#### SUBDIVISION REVIEW SHEET

CASE NO.: C8J-2021-0080.0ACOMMISSION DATE: May 24, 2022SUBDIVISION NAME: Whisper Valley Multifami> Parcel 65 Preliminary PlanADDRESS: 17001 E Braker LaneAPPLICANT: Club Deal 120 Whisper Valley, L.P.AGENT: Land Dev Consulting (Michael Giannetta)ZONING: Whisper Valley PUDMEIGHBORHOOD PLAN: N/AAREA: 16.2 acresCOUNTY: TravisMATERSHED: Gilleland CreekJURISDICTION: Limited Purpose

CITY OF AUSTIN – TRAVIS COUNTY – SINGLE SUBDIVISION OFFICE SUBDIVISION APPLICATION – MASTER COMMENT REPORT

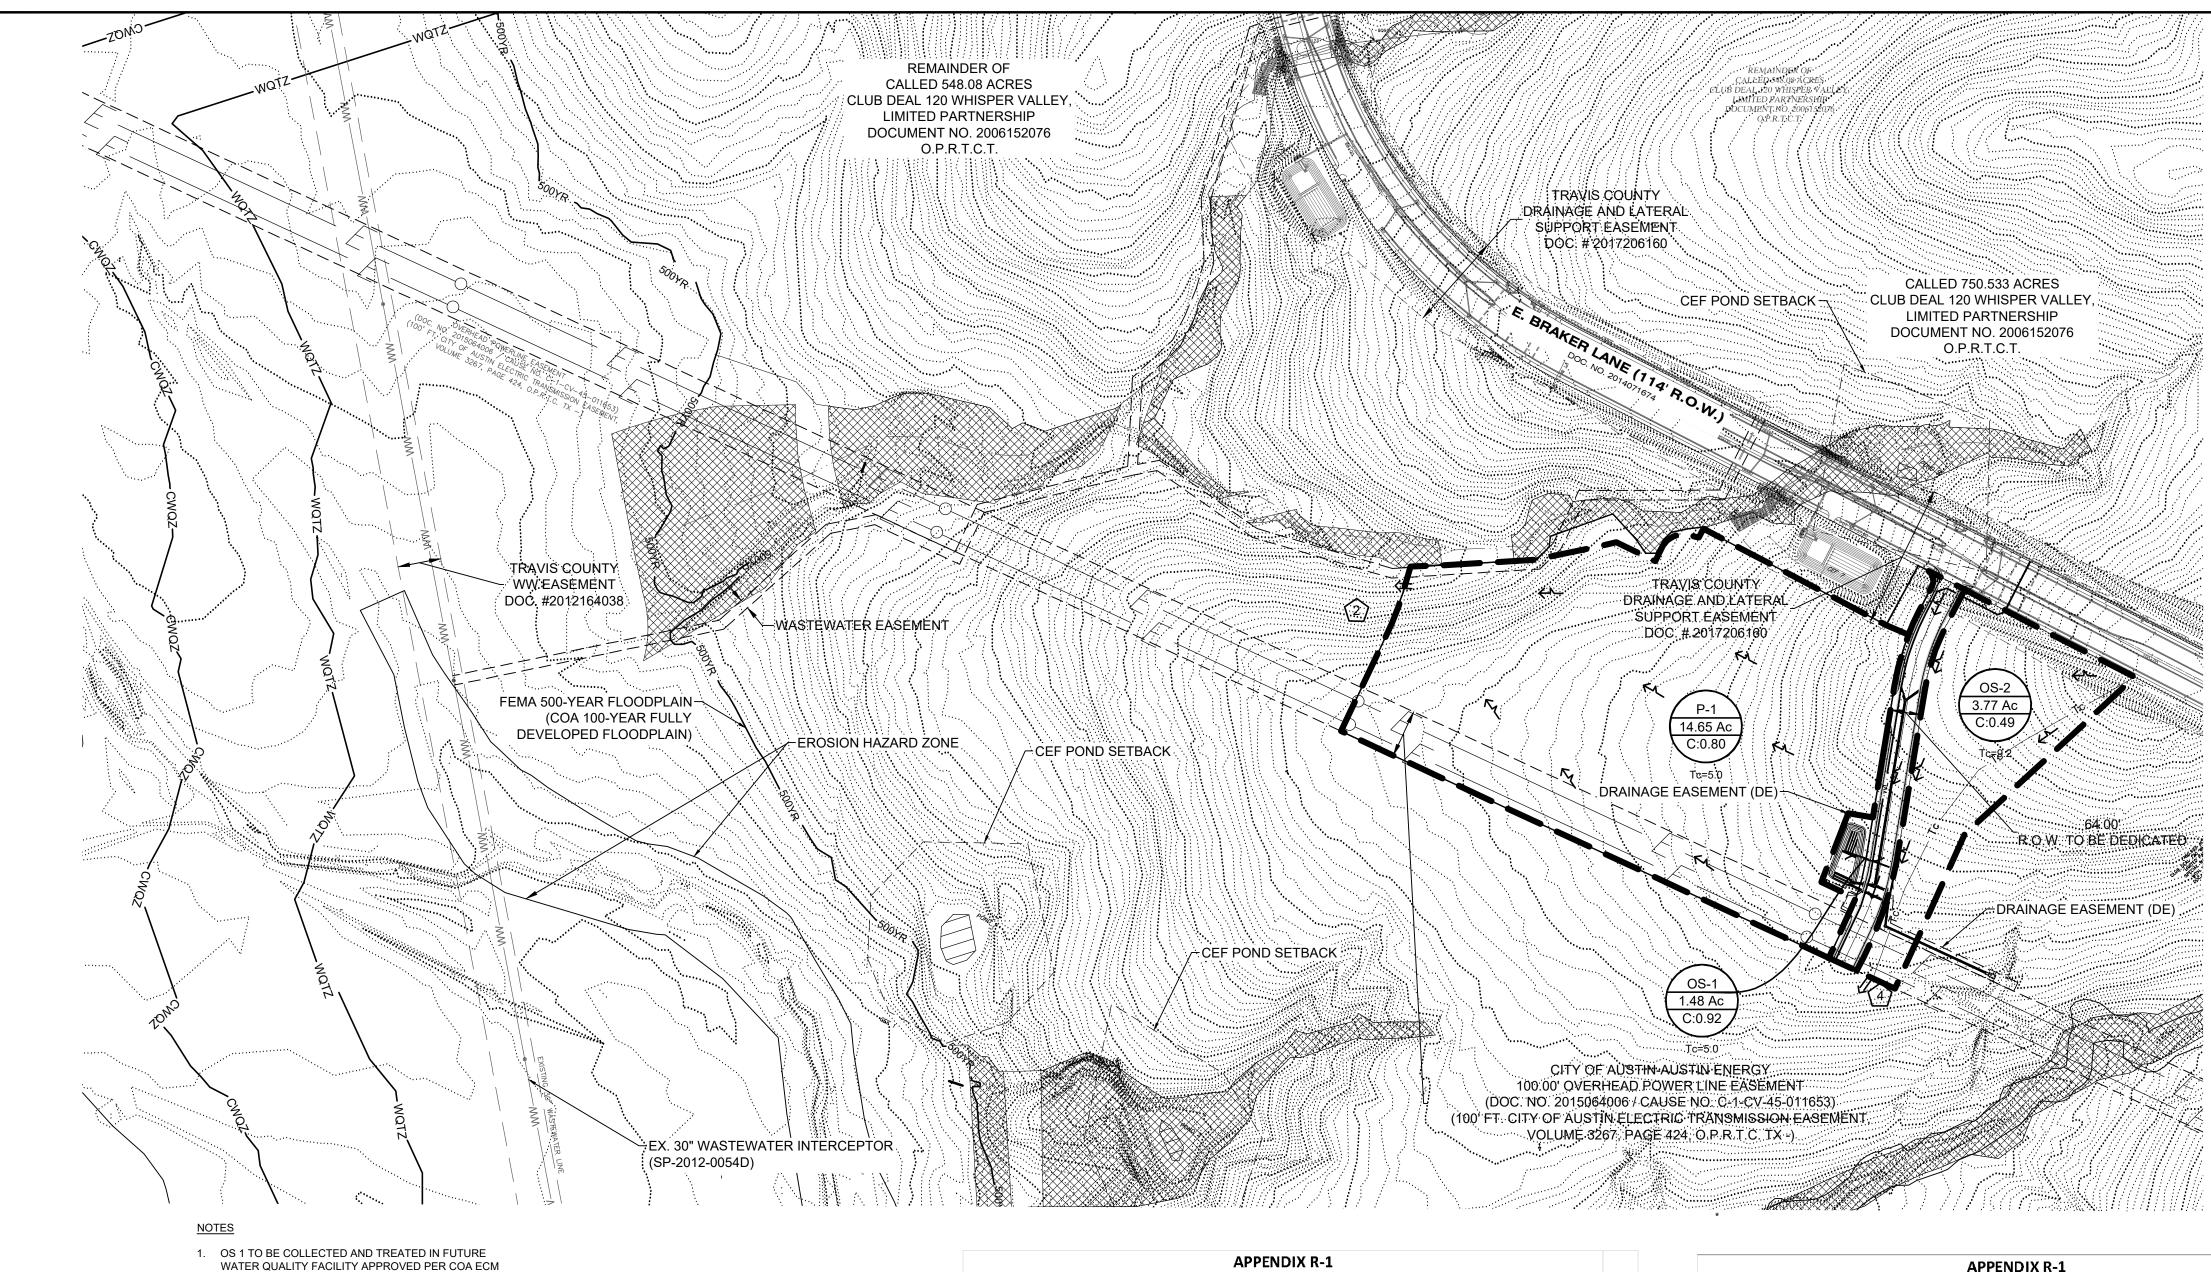
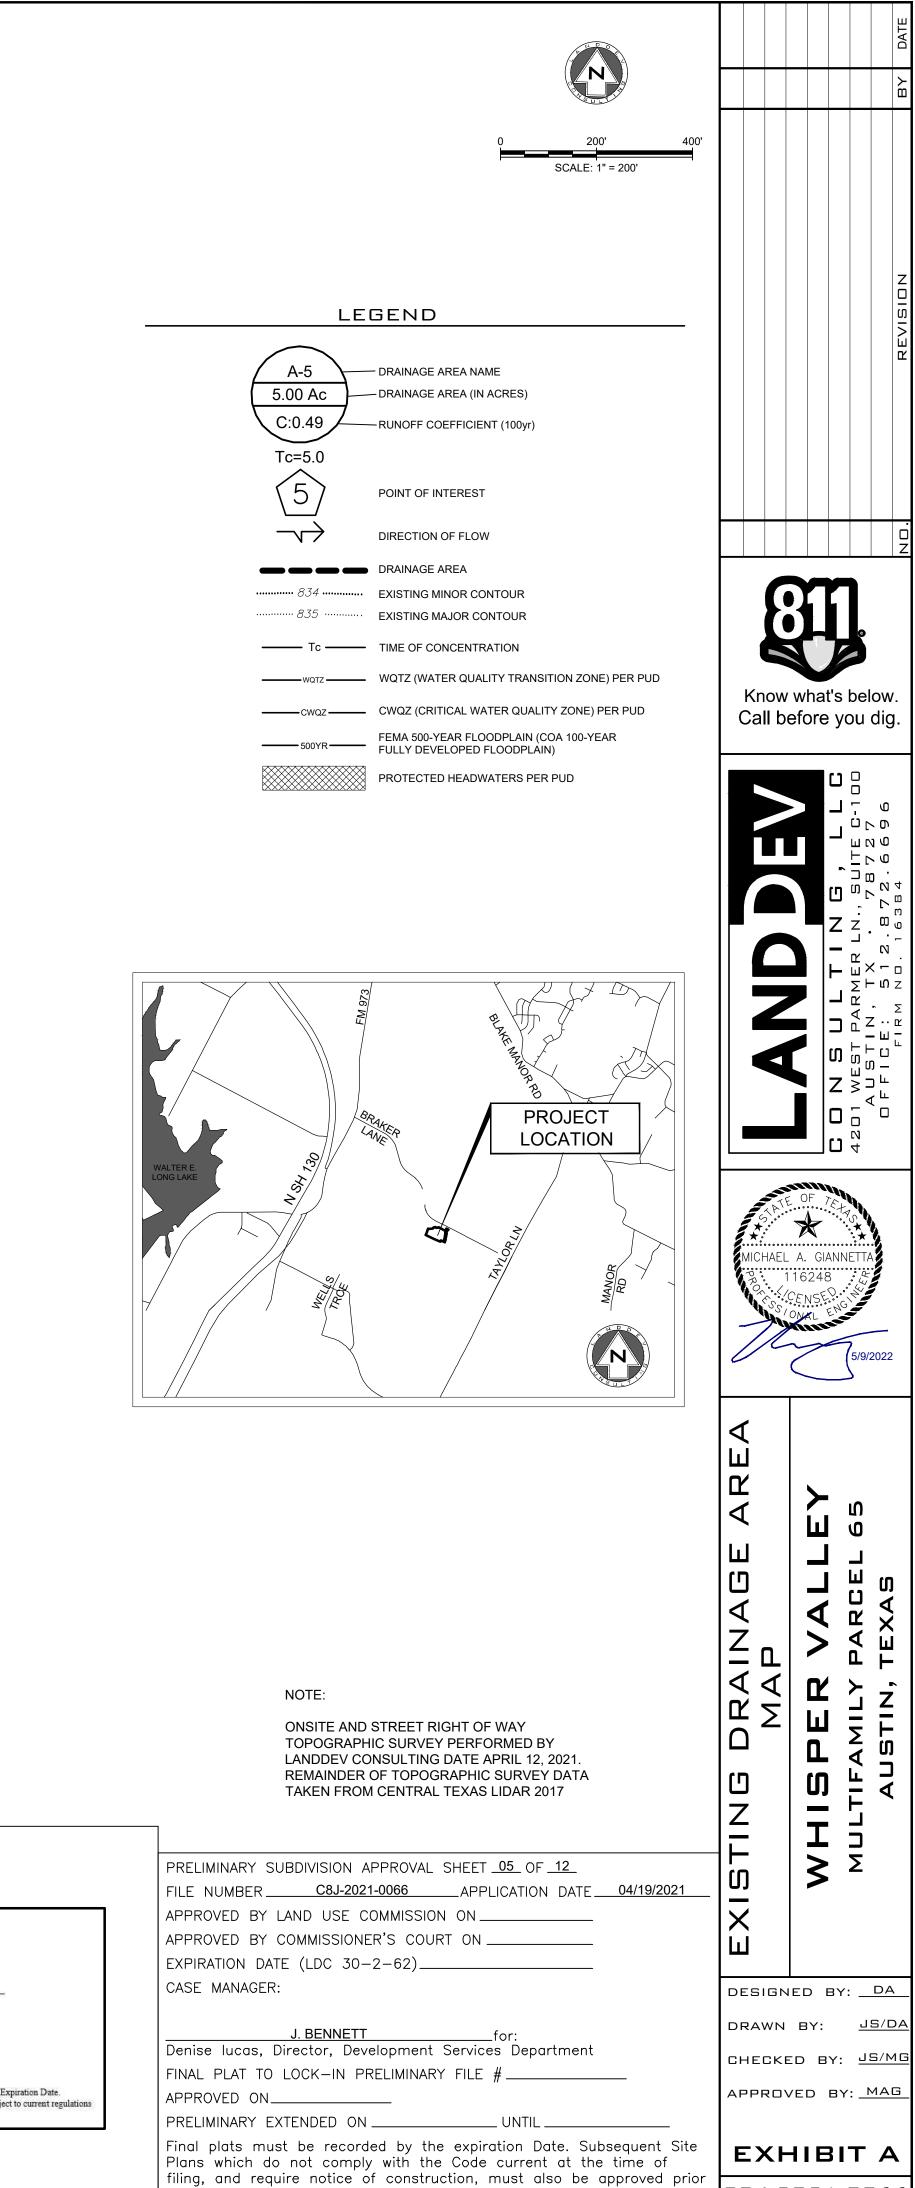
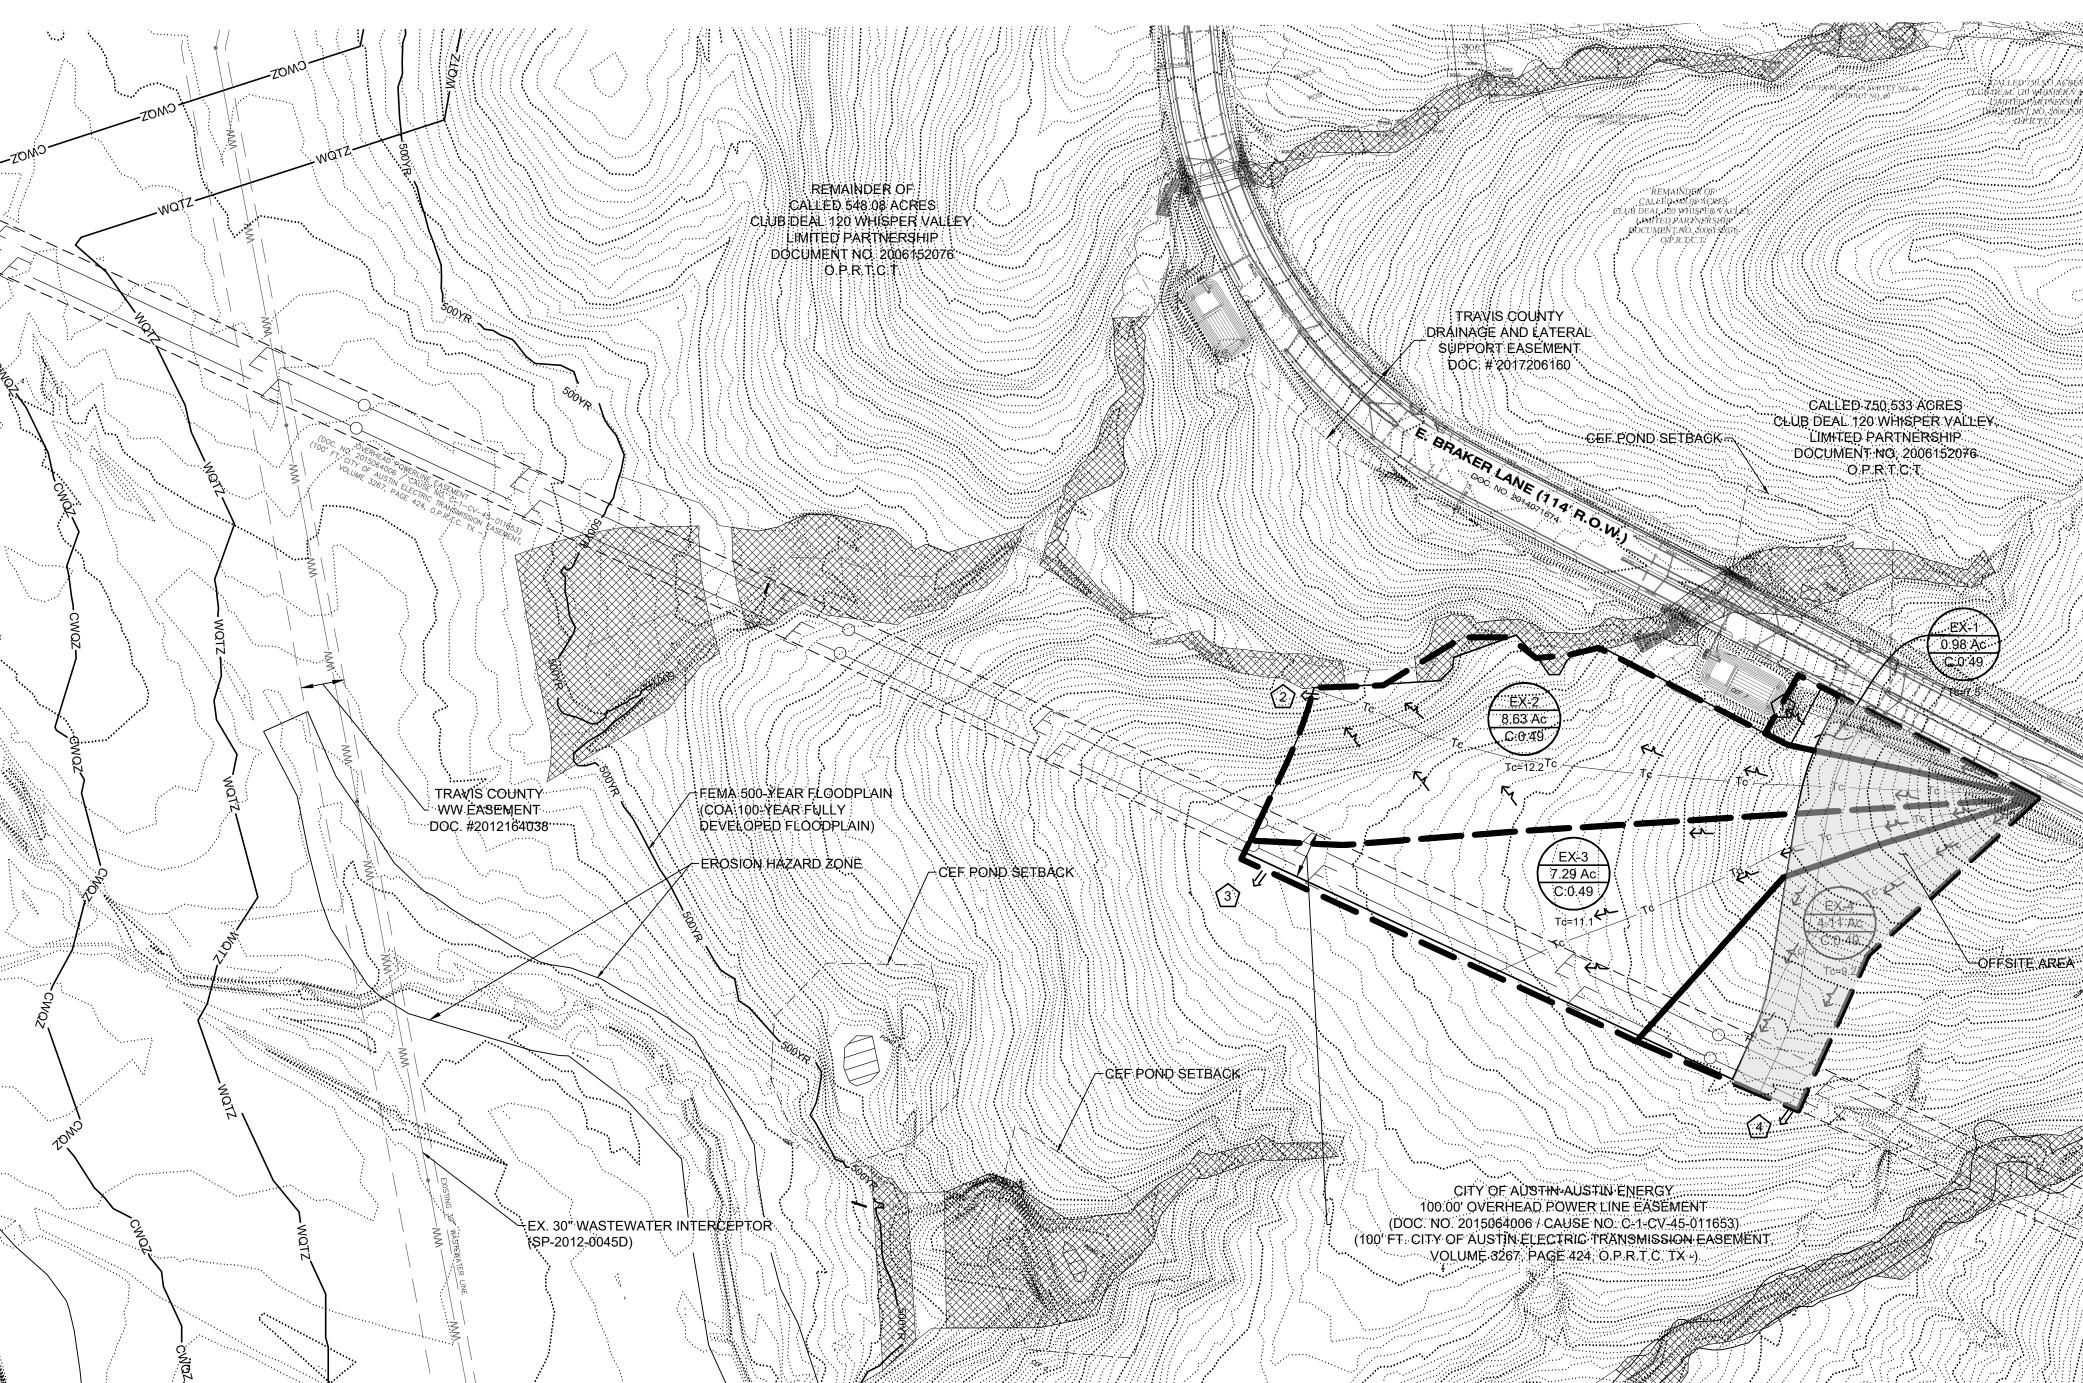
- DC 1. On Exhibit B in the Engineering Report I understand where POI 2 would be located, however I did not find it identified on the map; please include the designation and location for POI 2 for comparison with existing conditions peak flows at this location. Update comment 5/19/2022: A copy of the updated exhibit was not found with uploaded documents; please provide a copy of the updated Engineering Report that includes this updated exhibit.
- DC 2. It isn't clear where detention will be provided for the increased runoff related to Lilt Drive; mitigation for increases in peak stormwater runoff will need to be provided with the construction plans for this final plat. Please clarify.
   Update comment 5/19/2022: Please confirm where detention will be provided for Lilt Drive in your drainage plan for this final plat application.
